Product Change Notification / NTDO-23HTHI228

CCB 6113 Initial Notice: Qualification of MTAI as an additional assembly site for MCP6031T-E/OT, MCP6051T-E/OT, MCP6061T-E/OT and MCP6071T-E/OT catalog part numbers (CPN) available in 5L SOT-23 package.

PCN#: NTDO-23HTHI228

CCB#: 6113
Pre and Post Change Summary
PCN #: NTDO-23HTHI228

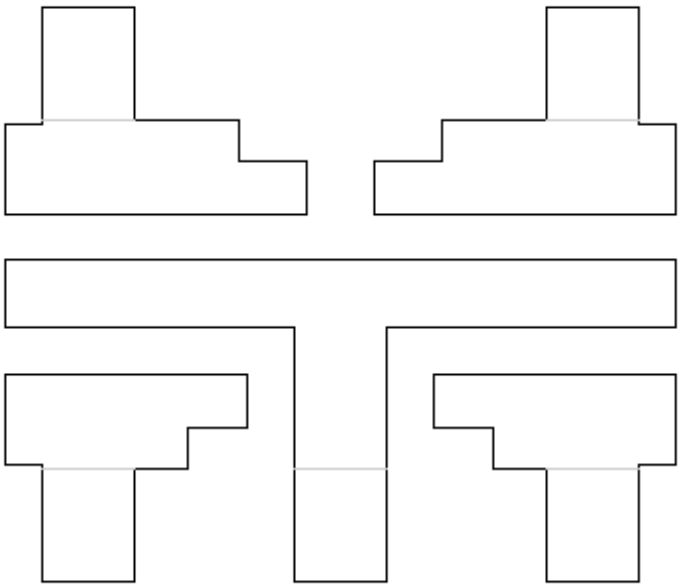
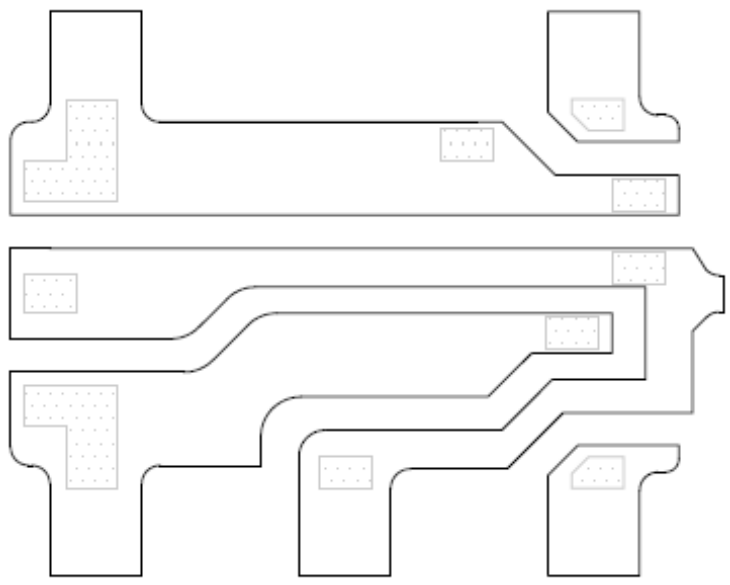
Description of Change:Qualification of MTAI as an additional assembly site for MCP6031T-E/OT, MCP6051T-E/OT, MCP6061T-E/OT and MCP6071T-E/OT catalog part numbers (CPN) available in 5L SOT-23 package.

| | | Pre Change | Post Change | |
|----------------------------|-------------------------|---|--|--|
| Assembly Site | | UTAC Thai Limited (UTL-1) LTD. (NSEB) | UTAC Thai Limited (UTL-1) LTD. (NSEB) | Microchip Technology Thailand (HQ) (MTAI) |
| Lead frame | Material | C194 | C194 | CDA194* |
| | DAP Surface Prep | Ag | Ag | Ag-selective |
| | Treatment | No | No | Roughening |
